CITY OF ALBUQUERQUE

**RE: Mister Car Wash - 98th St. & Volcano Rd.
Grading and Drainage Plan & Drainage Report
Engineer's Stamp Date: 03/14/19
Hydrology File: K08D004**

Based upon the information provided in your submittal received 03/14/2019, the Grading & Drainage Plan and Drainage Report **is not** approved for Building Permit, Grading Permit, Work Order, and for action by the DRB on Platting and Site Plan for Building Permit. The following comments need to be addressed for approval of the above referenced project:

PROPOSED BASIN MAP

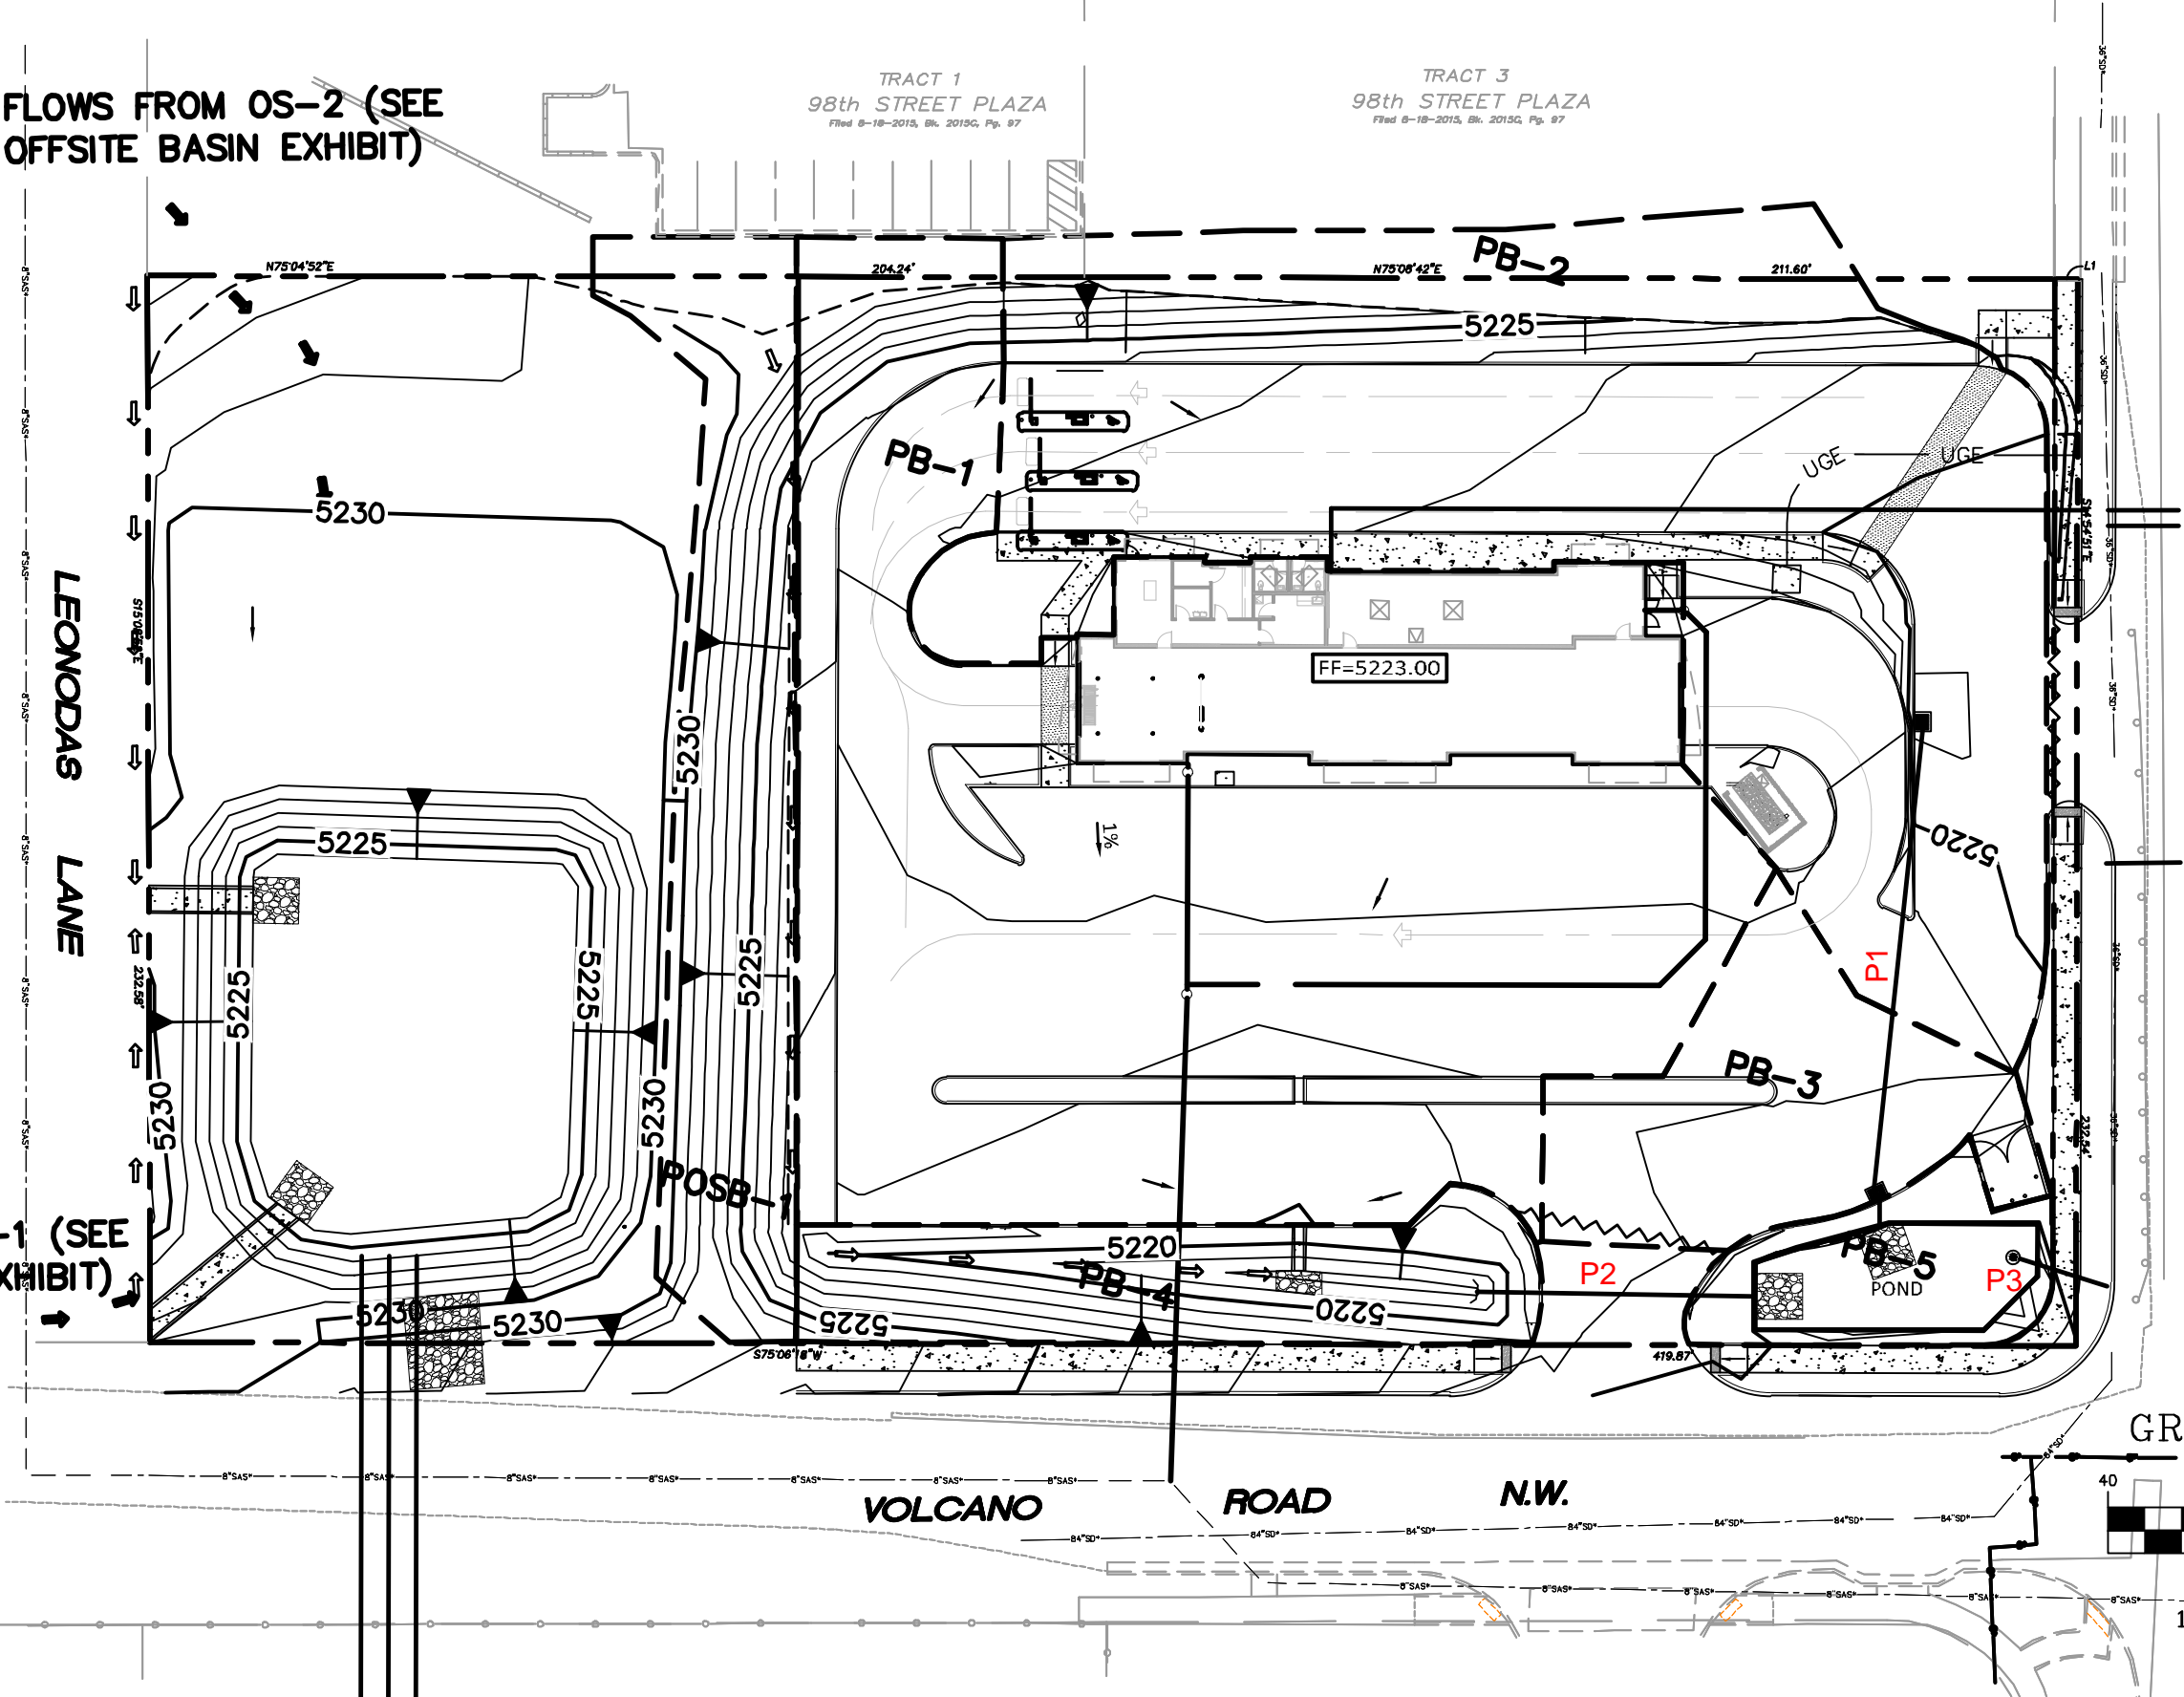
3. Drainage Report. Please label "POSB-1" in the Proposed Basin Map Exhibit.
4. Drainage Report. Please remove the Worksheet for Capacity Check of Pipe Culvert P-2. This is a culvert and the calculation report for the culvert was done.

STORMCAD - 98TH ST STORM SEWER SCHEMATIC

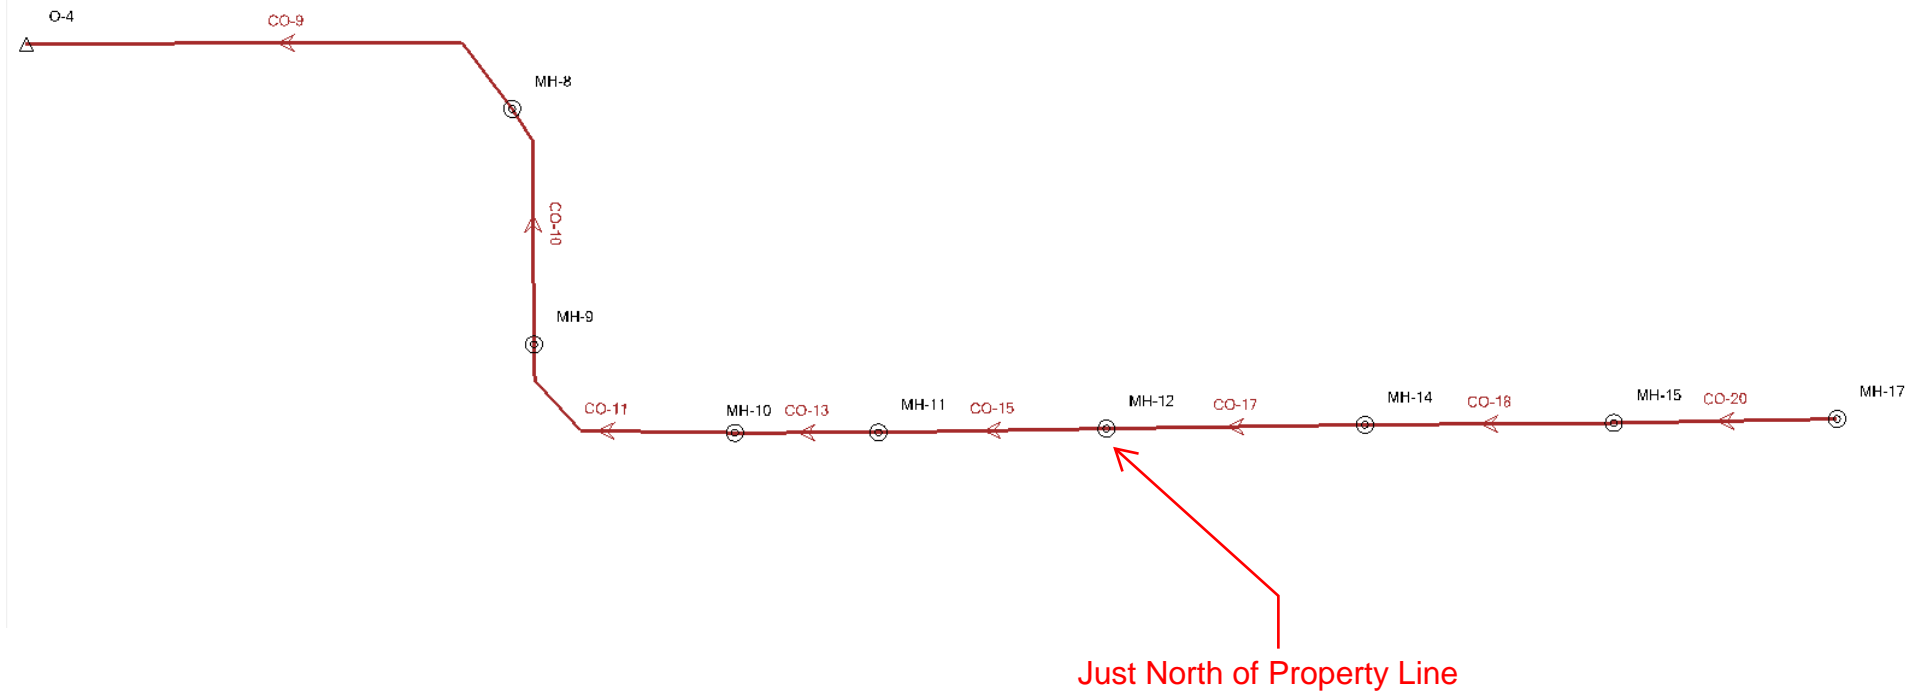
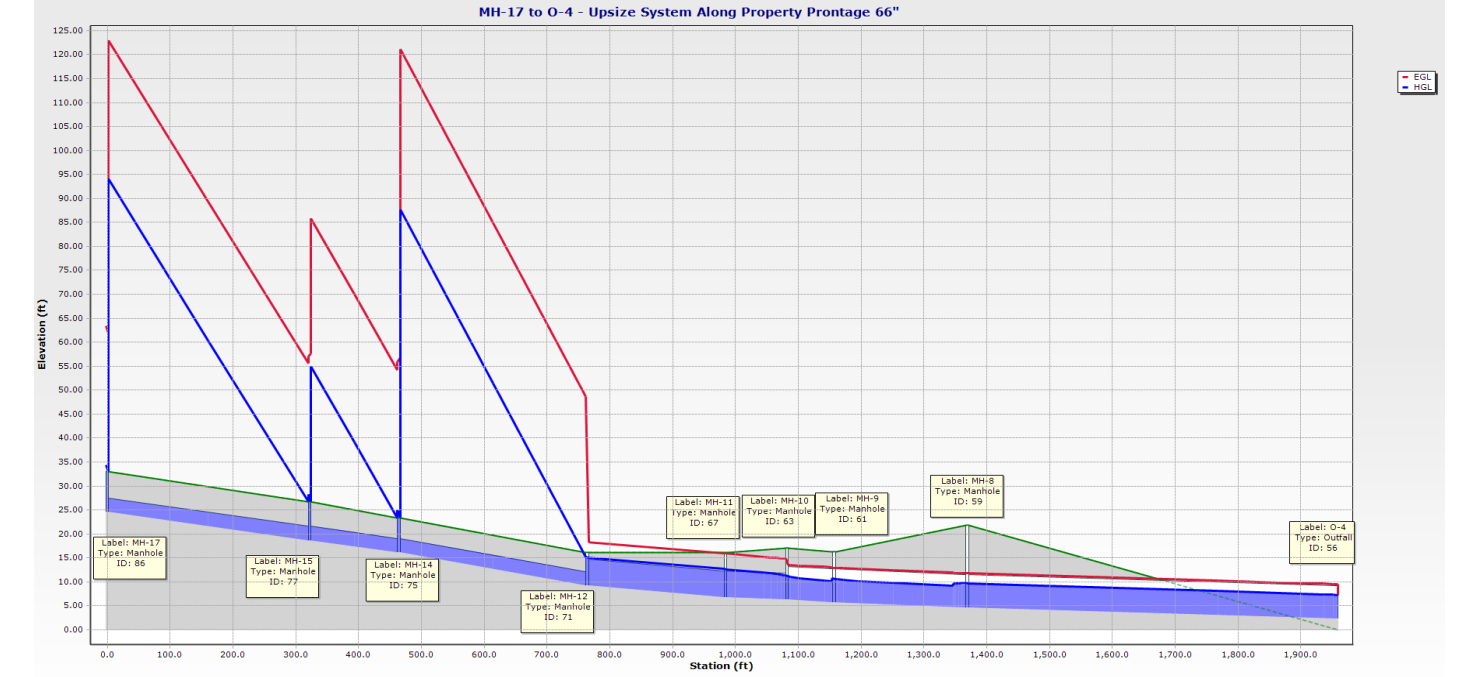
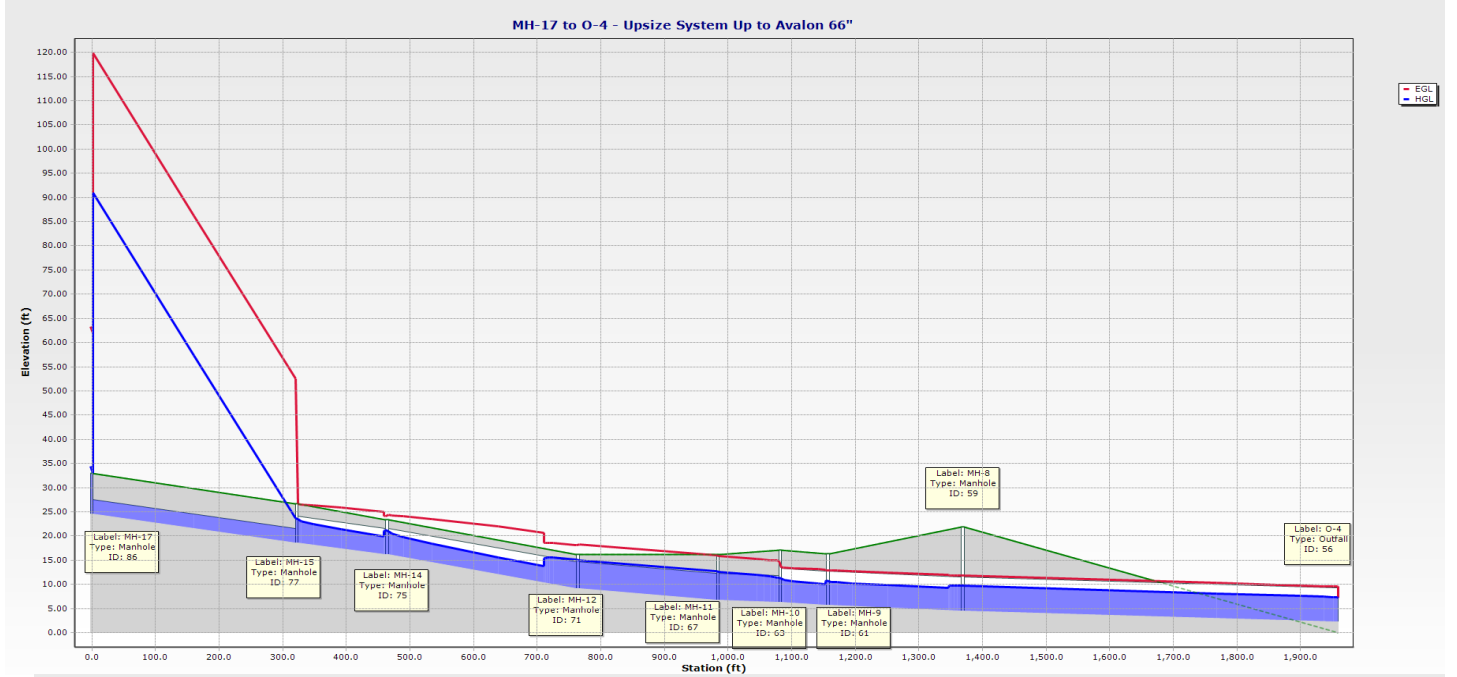
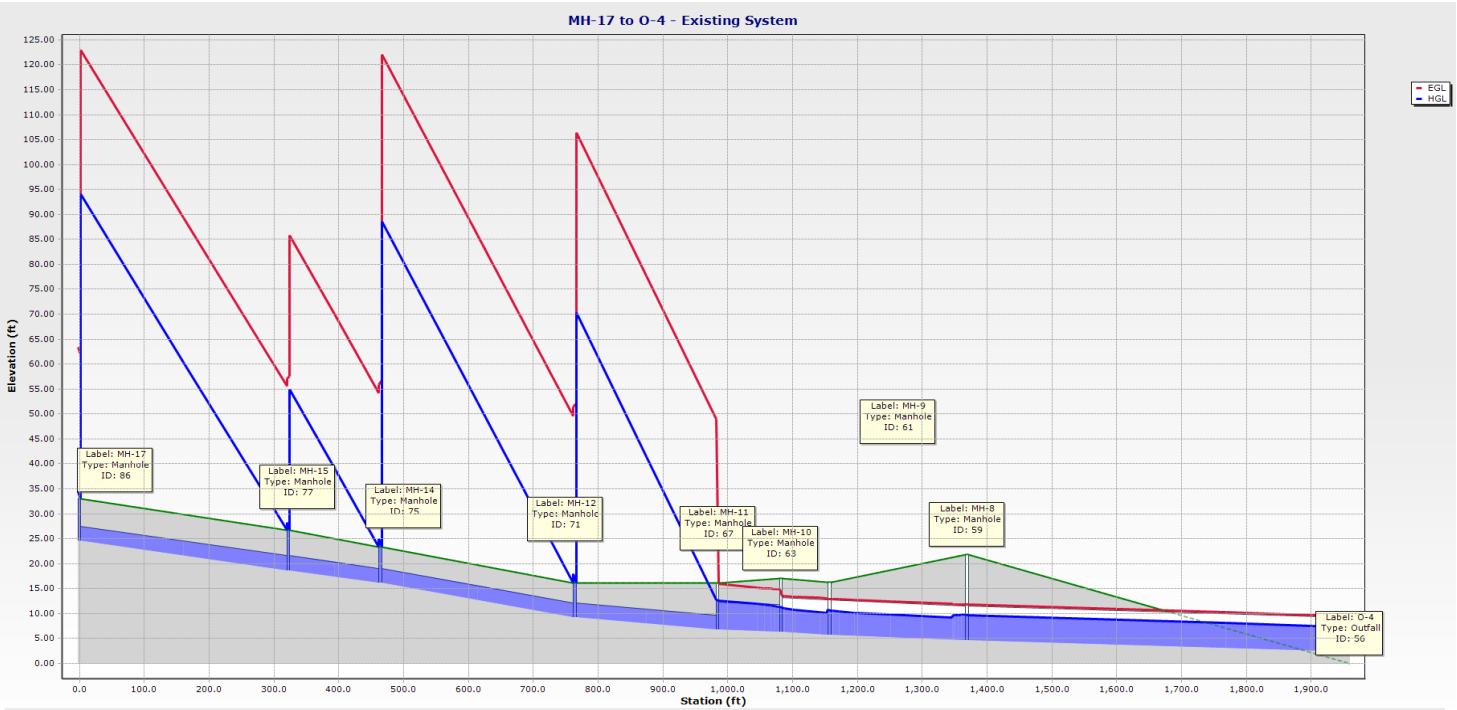
5. Drainage Report. Please revise the title of the above mention culvert calculation report from "P-3" to "P-2".
6. Drainage Report. Please plot the StormCAD profiles on individual sheets.
